LOWLANDS AREA PLANNING SUB-COMMITTEE - MONDAY, 8TH JANUARY, 2024

Application Number	23/02849/FUL
Site Address	Land South West Of Chapel Lane Standlake Oxfordshire
Date	5th January 2024
Officer	Esther Hill
Officer Recommendations	Refuse
Parish	Standlake Parish Council
Grid Reference	439750 E 203347 N
Committee Date	8th January 2024

Erection of a dwelling with double garage, adapted vehicular entrance point and related landscaping

CHAPEL LANE, STANDLAKE
MR PATRICK STEEPE
MARCH 2021
4212-CHAP-ICS-XX-RP-C-07.001-P07

Trial Hole Location

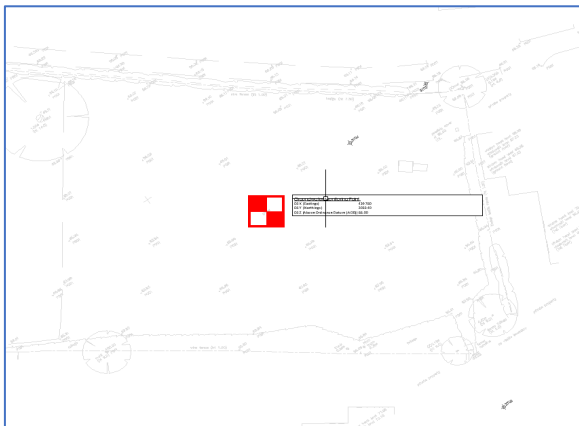
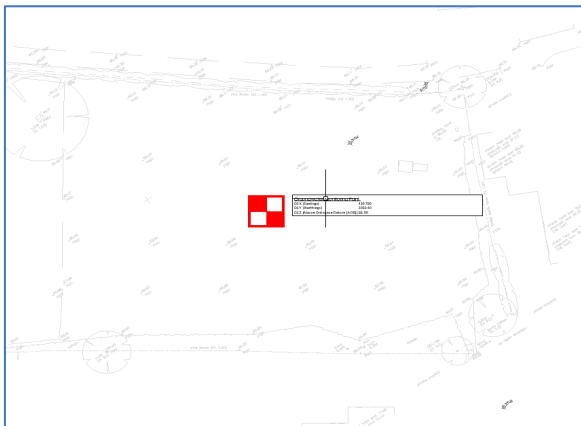
The current design achieves 304mm clearance of the base of the infiltration feature and the highest recorded groundwater level (this week). The latest reading has been taken into account with the current design.

As you have stated it is proposed to raise levels of the lower site, can you please confirm by how much it is currently proposed to raise them by and whether the latest groundwater reading has been taken into consideration with regards to the base level of the permeable paving, i.e. is there any scope for raising the ground levels further?

Date	Measurement from ground level to water/mm	Approximate level (Above Ordnance Datum [AOD])/m
26 November 2022	590	65.41
10 December 2022	590	65.41
24 December 2022	590	65.41
07 January 2023	590	65.41
21 January 2023	590	65.41
04 February 2023	735	65.27
18 February 2023	800	65.20
28 February 2023	800	65.20
06 October 2023	1020	64.98
13 October 2023	900	65.10
24 October 2023	880	65.12
27 October 2023	740	65.26
03 November 2023	670	65.33
10 November 2023	590	65.41
17 November 2023	590	65.41
24 November 2023	670	65.33
01 December 2023	670	65.33
08 December 2023	590	65.41
20 December 2023	595	65.41
26 December 2023	670	65.33
02 January 2024	330	65.67

Drainage Strategy

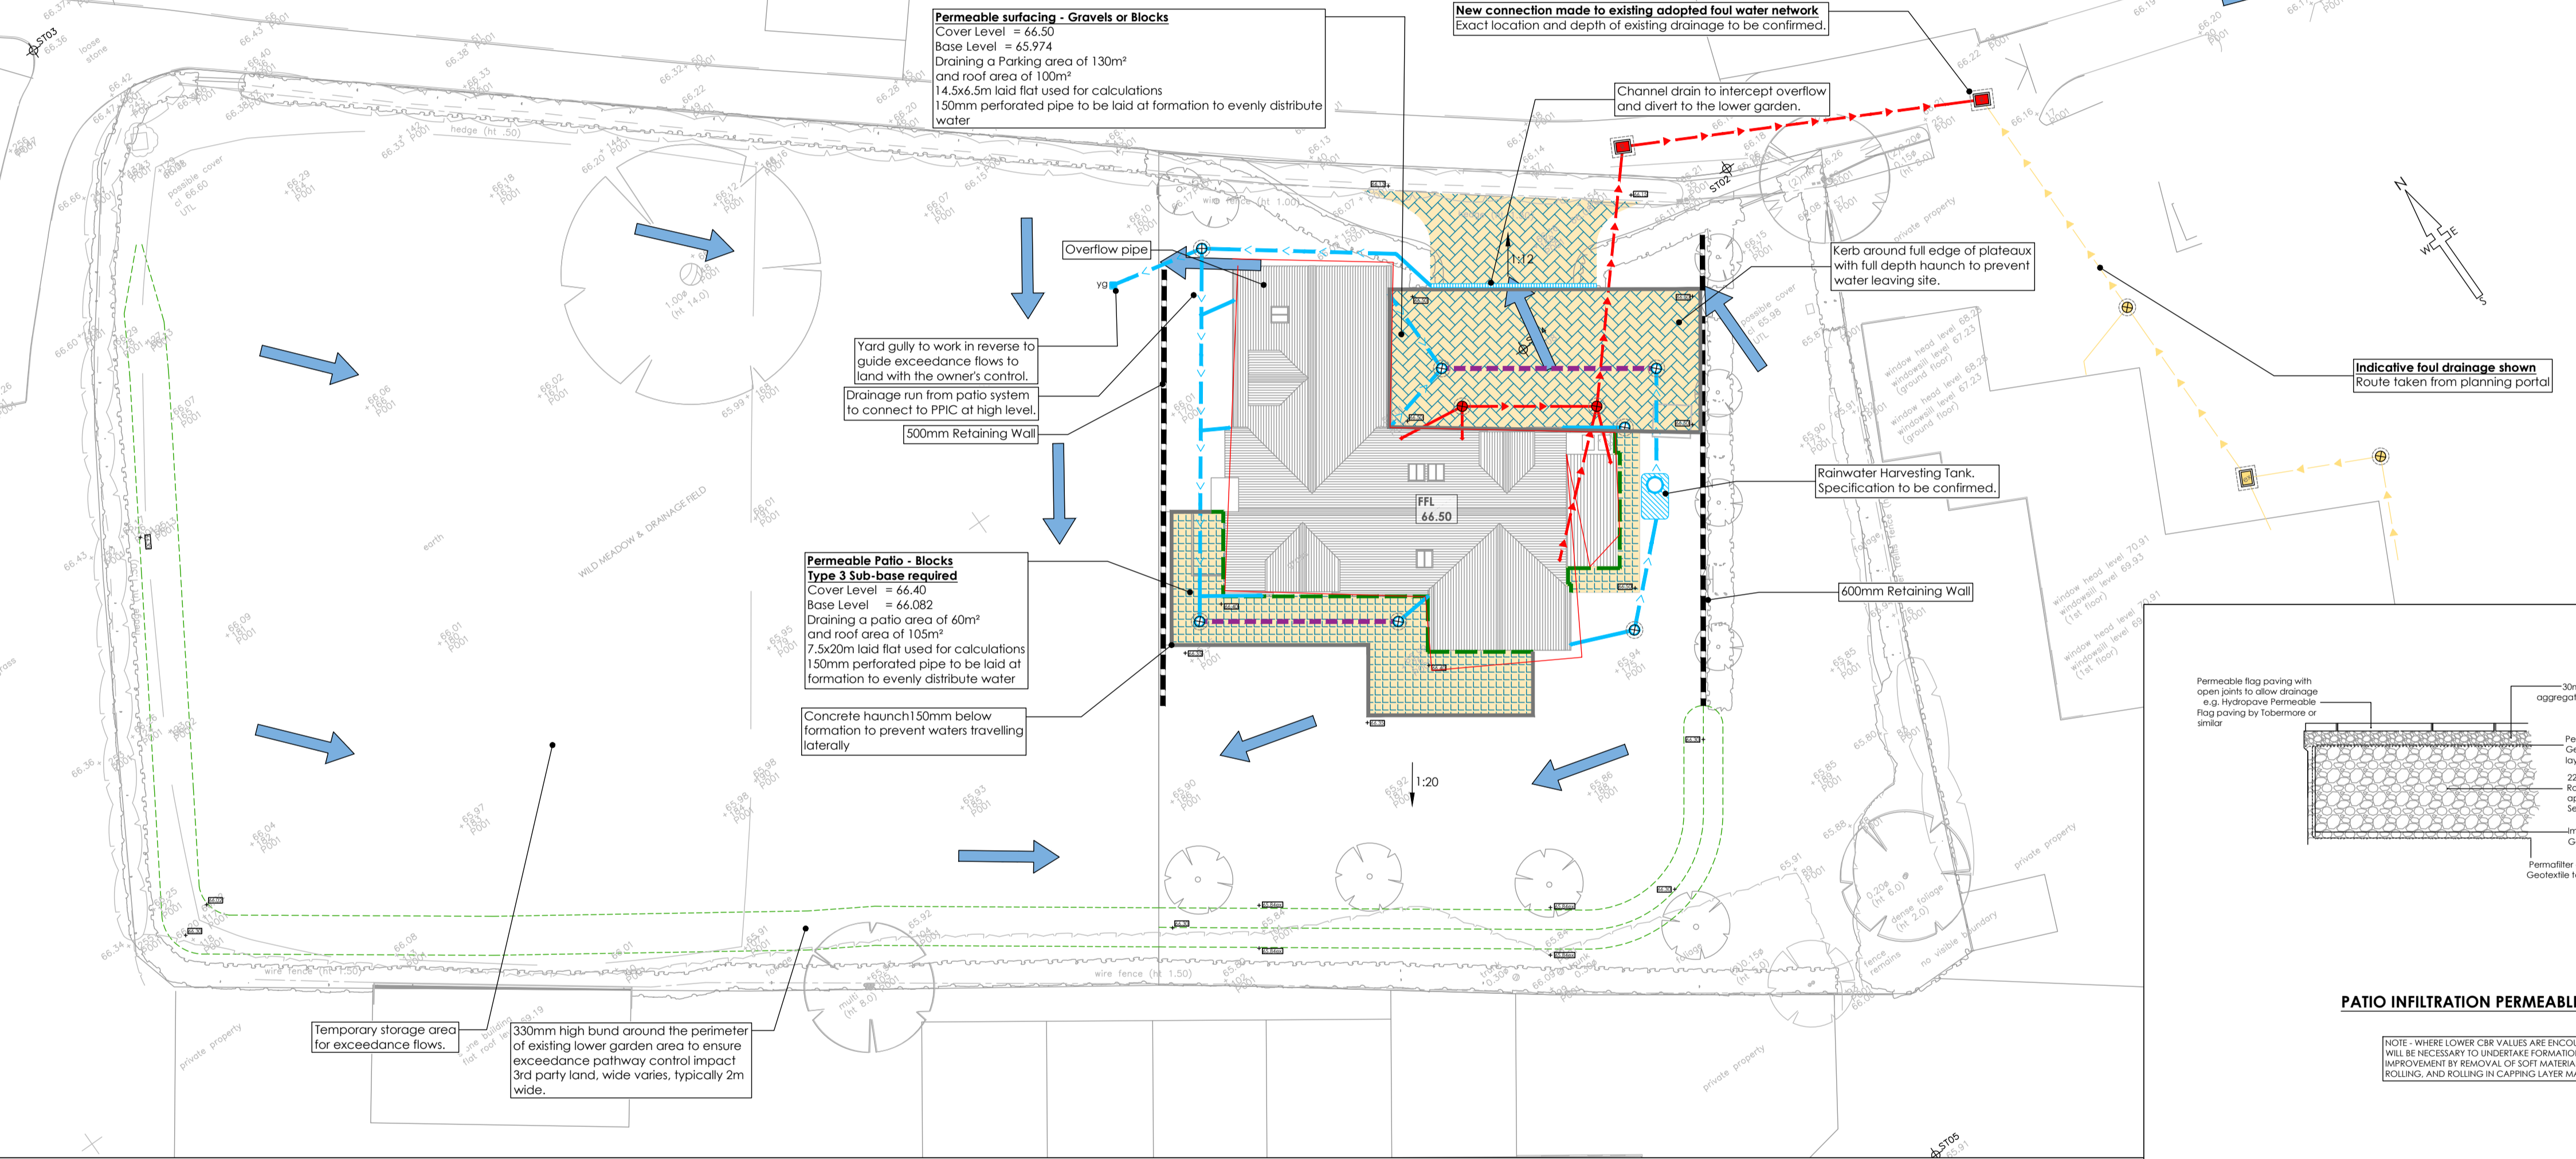
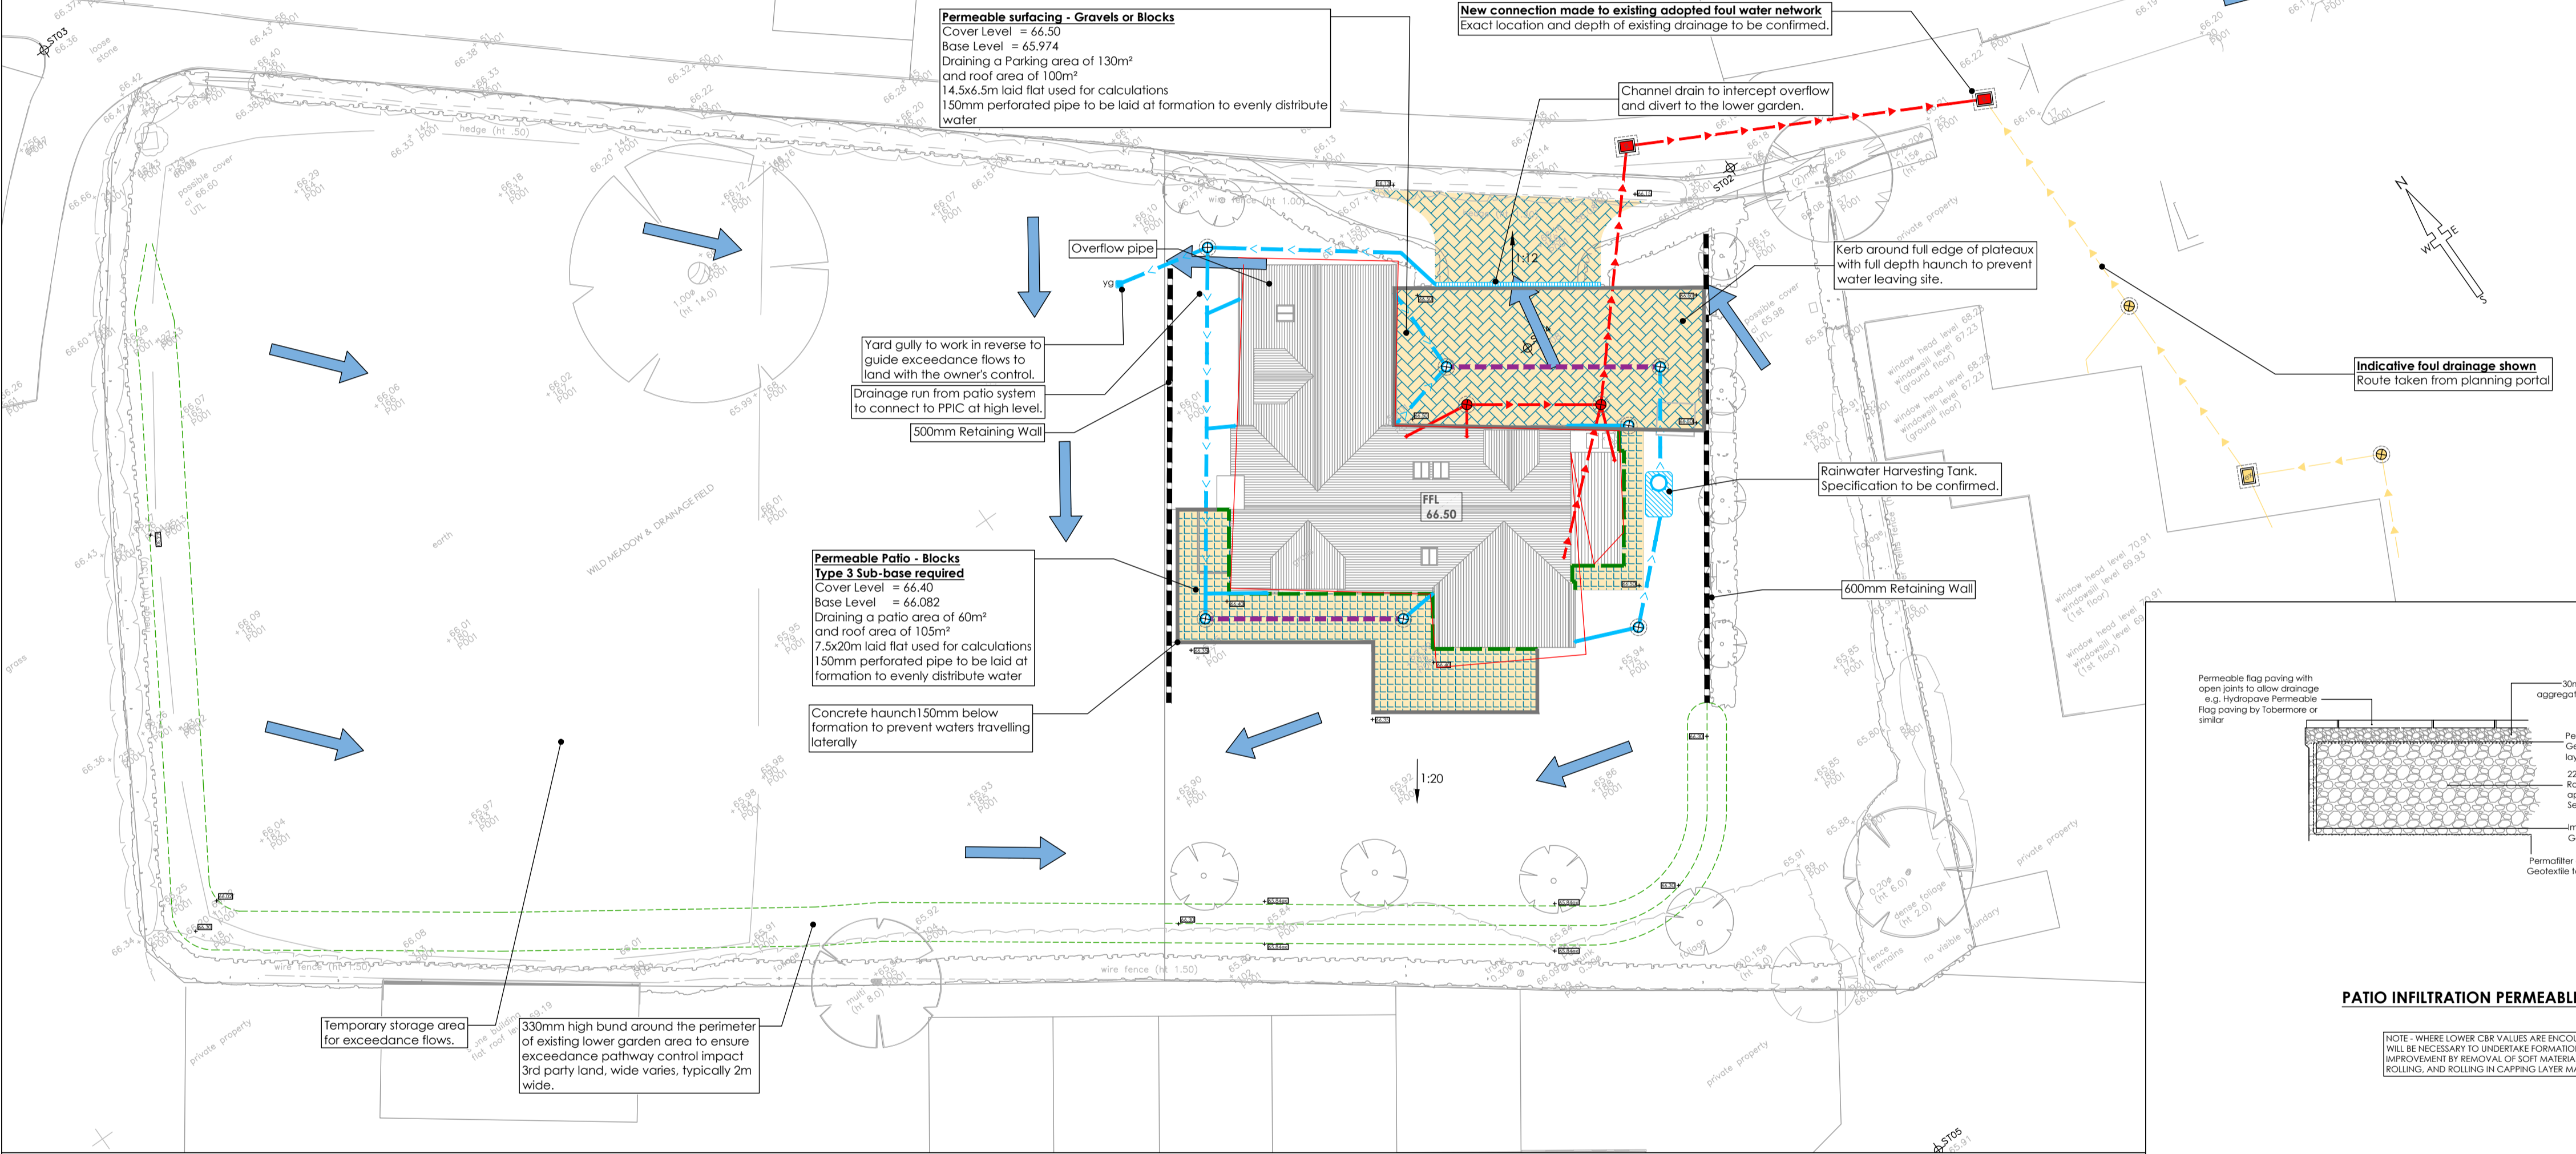
C753 indicates that 300mm should provide sufficient depth for treatment between permeable paving and a high groundwater table, we are providing 304mm. An extract from C753 is below, see below and note 3:

The parking is already 420mm higher than the existing ground level at the location of the paving (it was 66.08, it will be 66.50).

To the rear of the dwelling is 550mm higher, the existing levels are currently 65.95, and the FFL is proposed to be 66.50.

We are hopeful that, at this stage, the plans and measurements provided show that the design is achievable and that the drainage can be conditioned. If the offset to the groundwater needs to be increased further, the paving depth could be reduced to provide a larger offset; these displaced waters would then be guided to the floodable area to the rear, which is many times oversized. Or the sub-base could be replaced with permavoid (or similar) to provide the same storage in a

Unfortunately, with the very large number of flooding-related objections received for this latest application, a handwritten note of groundwater depths without corroborating borehole logs is not going to be sufficient to satisfy the concerns, especially as the same figure (590mm) keeps cropping up. Although a further soakage test has been carried out which indicates similar infiltration to before, formal evidence that groundwater will not be an insurmountable issue is required to be submitted before I can remove my objection.

NO	DATE	BY	REVISION	REVISION COMMENTS	ISSUE DATE
P08	NJ	RJW	Amended in line with revised site layout		22/12/23
P07	NJ	RJW	Amended in line with revised site layout		16/10/23
P06	AA	RJW	Overflow added to surface water system to ensure exceedance flows are retained within private land.		03/10/23
P05	RSI	RJW	Updated in line with the comments from drainage officer		08/06/23
P04	NJ	RJW	Existing levels to rear of gardens corrected		24/04/23
P03	NJ	RJW	Driveway layout updated in line with proposed site plan		18/04/23
P02	BMK	RJW	Drainage design amended in accordance with redesigned site layout		22/07/22
P01	AC	RJW	Initial issue		16/03/21
